**Historic Landmarks Committee
Hybrid In-Person & ZOOM Online Meeting
Wednesday, May 28 - 3:00 PM
Community Development Center, 231 NE 5th Street**

DATE: May 28, 2025
TO: Historic Landmark Committee Members
FROM: Matthew Deppe, Associate Planner
SUBJECT: DDR 2-24 (Downtown Design Review Waiver)
645 NE 3rd Street

DECISION, CONDITIONS, FINDINGS OF FACT AND CONCLUSIONARY FINDINGS OF THE PLANNING DEPARTMENT FOR THE REVIEW OF AN APPLICATION FOR DOWNTOWN DESIGN REVIEW FOR EXTERIOR ALTERATIONS TO AN EXISTING BUILDING AT 645 NE 3RD STREET WITHIN THE DOWNTOWN DESIGN AREA

1 SOUTH ELEVATION
2.0 1/4"=1'-0"

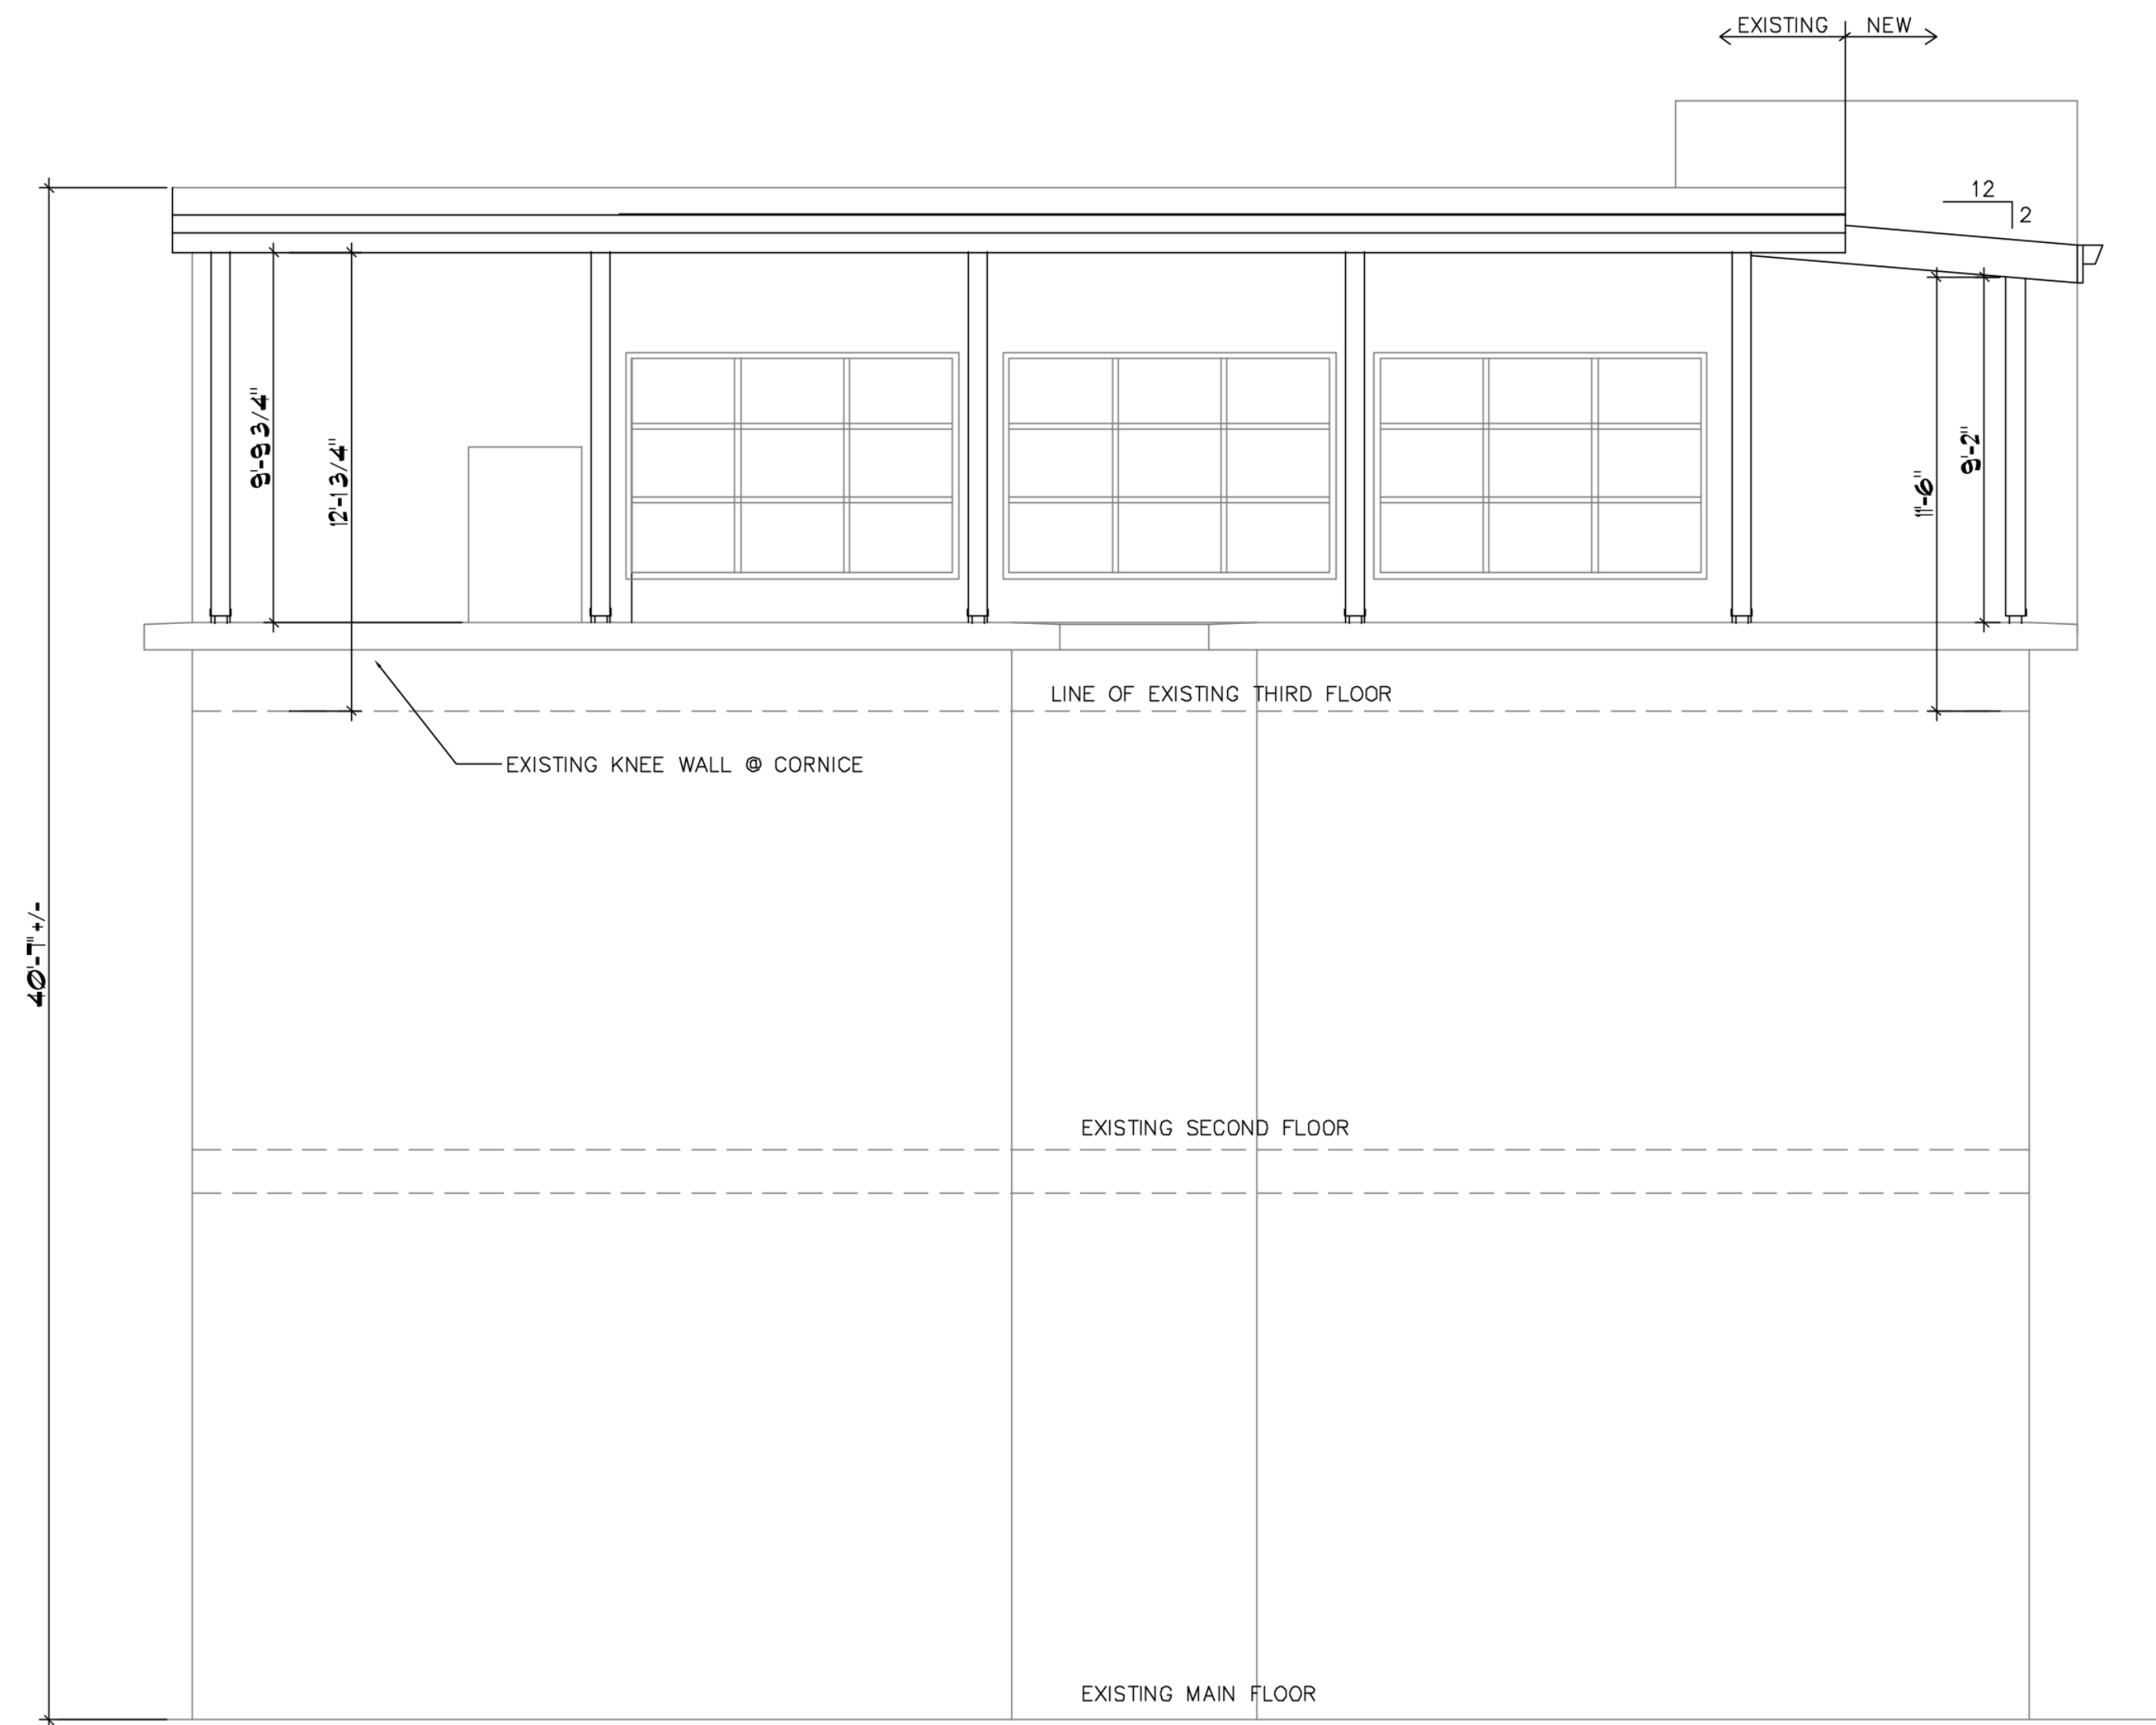
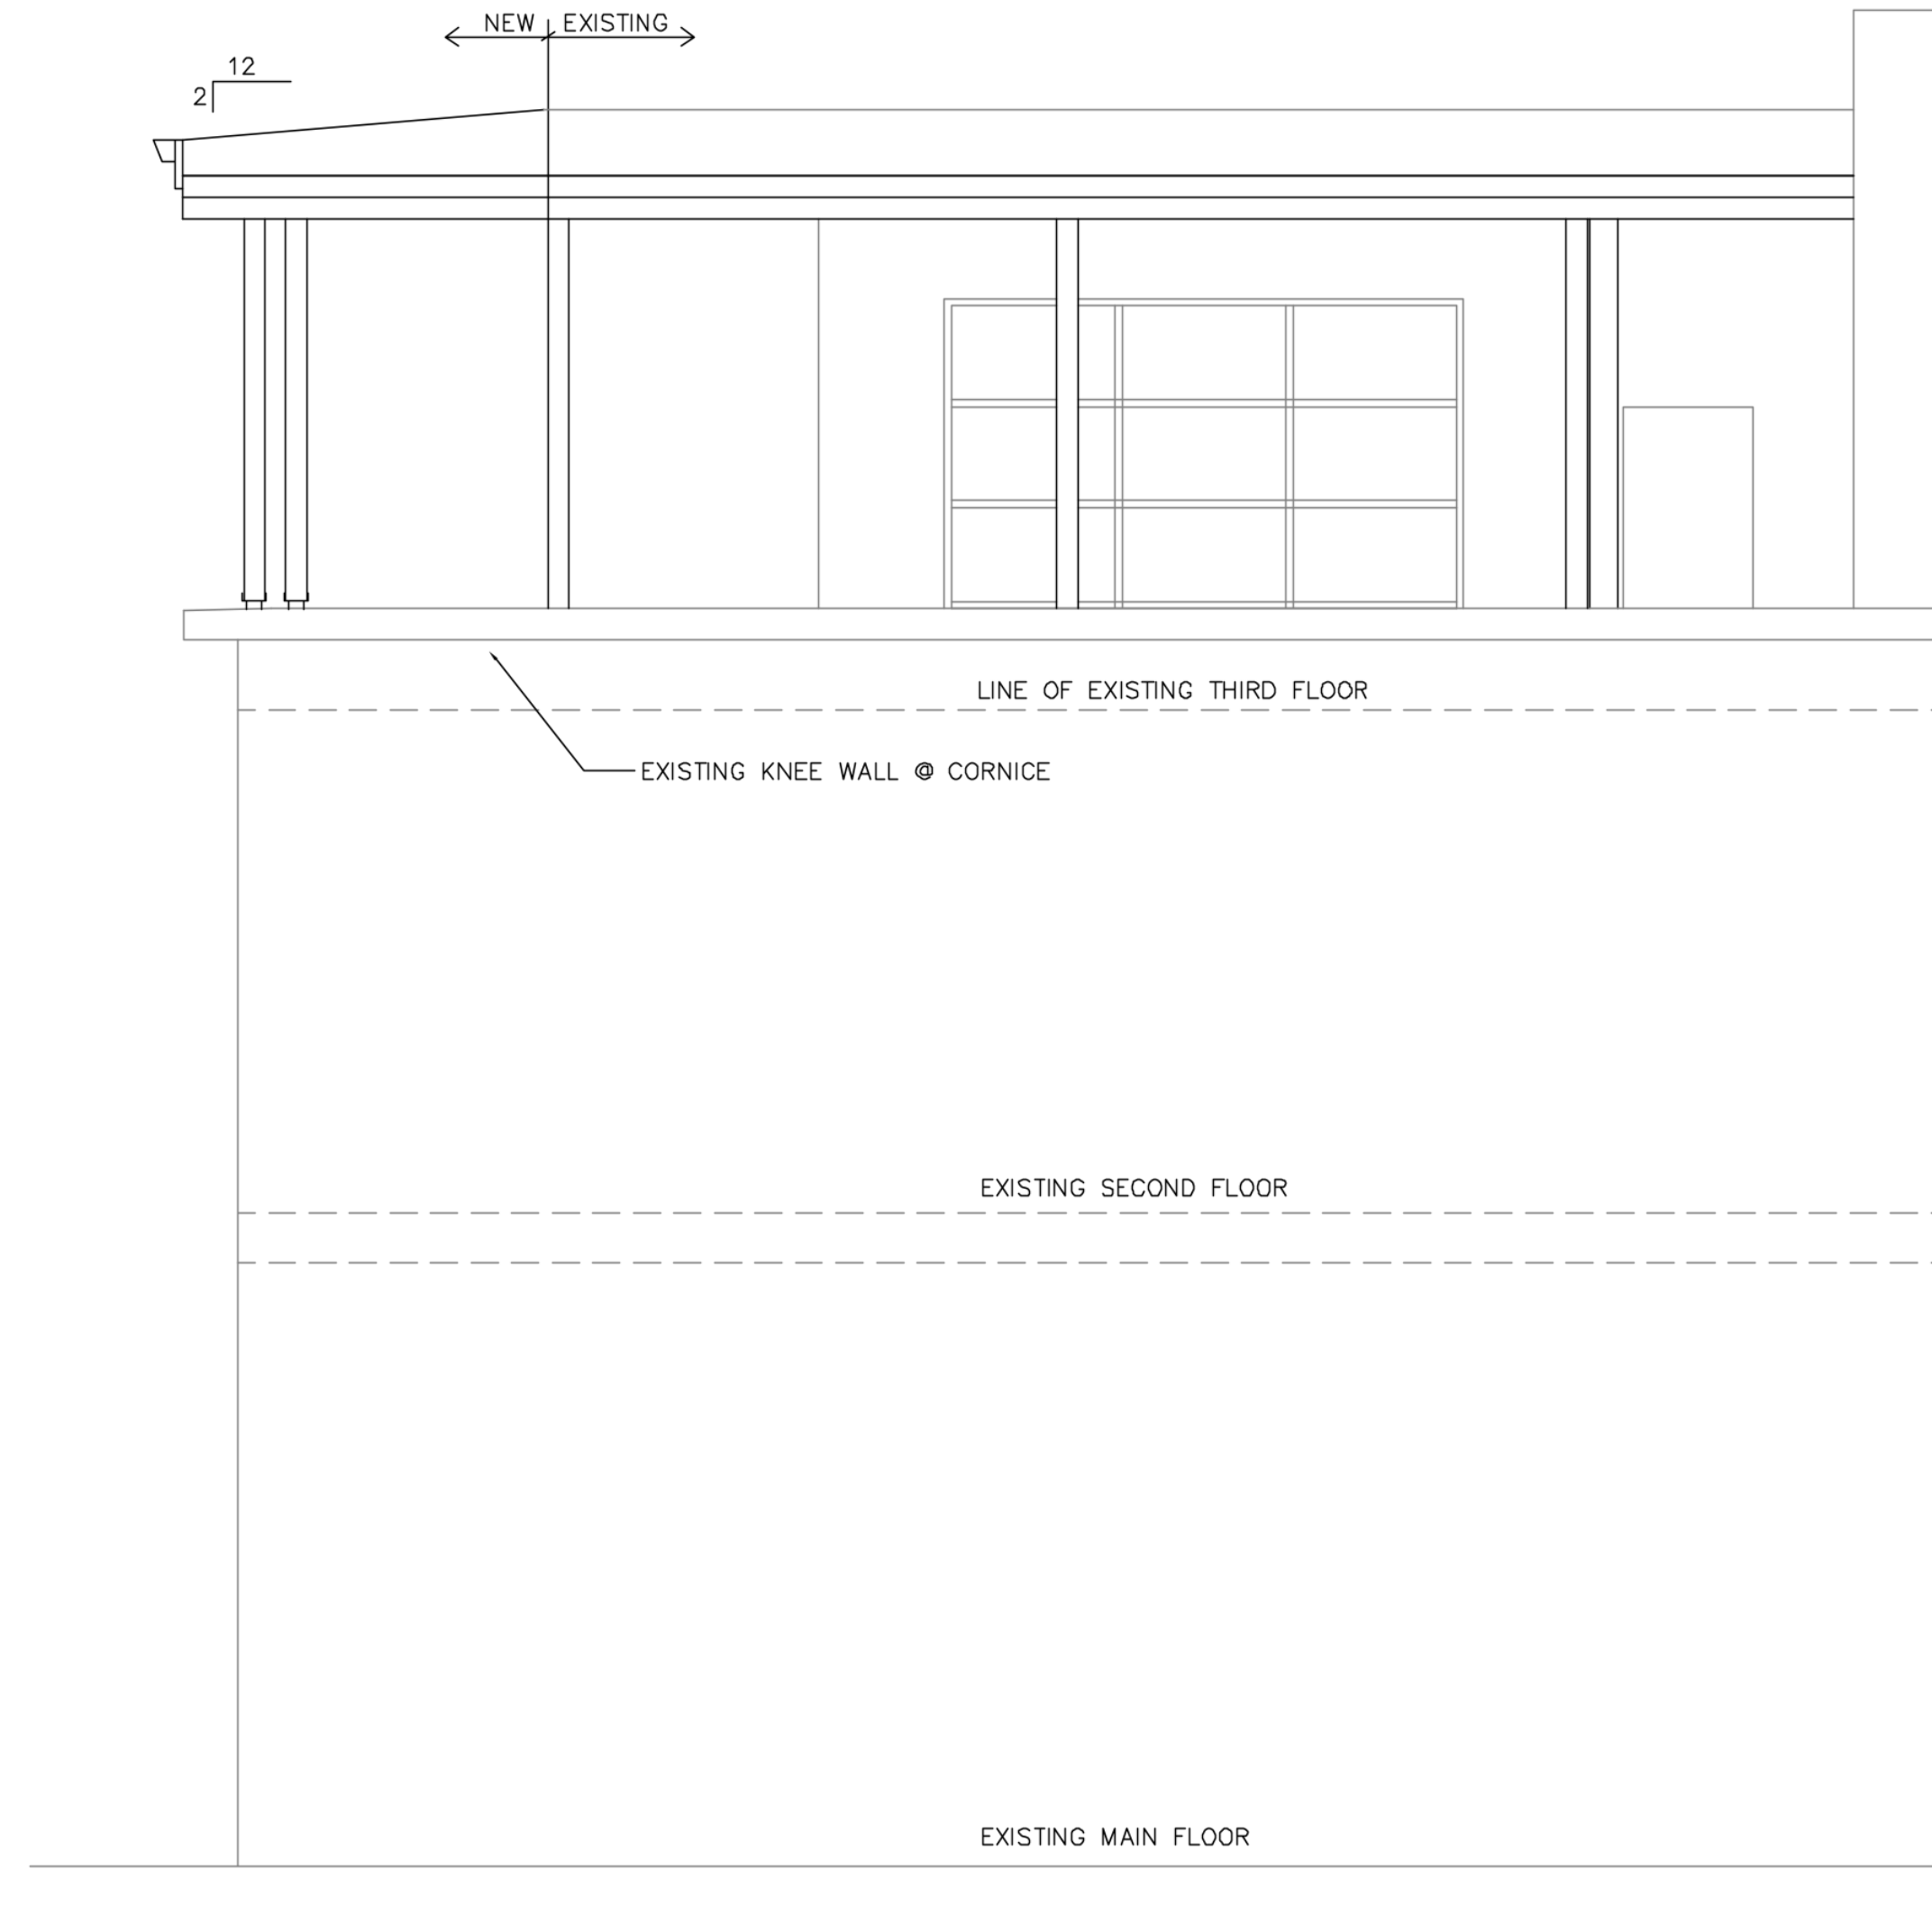
Finding: The applicant has argued that "the current structure's roofline design was created to assist in the scale and massing of the building relative to its neighbors while still providing for a 3rd floor space and an attractive rooftop seating area. To add a cornice to the patio cover extension would destroy the intentional scale and the rooftop design. Since this is not a "true" 3rd story it would seem to be a strange design addition. In addition the second floor of the building has a decorative cornice to help achieve the desired design standard."

The applicant has also argued that "the structure was originally granted a waiver for the use of wood siding. While we are not adding any siding we do plan to use stained wood posts. The posts will be stained dark brown to match the rest of the posts on the building. Painting the wood posts would likely make this award winning building less cohesive since there are no other painted wood posts on the building."

Staff recognizes that working with an existing design waiver poses a unique challenge. Staff also notes that it was the "not a true 3rd story" nature of the design that contributed to the approval of the design. Bringing the 3rd story out to the edges of building seems to undermine that basis of approval. This significant change brings into question whether the initial approval would have been granted if the design would have continued to edge of the building. This location is more visible at the street level and extends the use of the prohibited materials. Generally, painted wood is limited to window frames and door frames on the existing historic structures downtown. It is the staff's understanding that that is the sole intended application of that listed material.
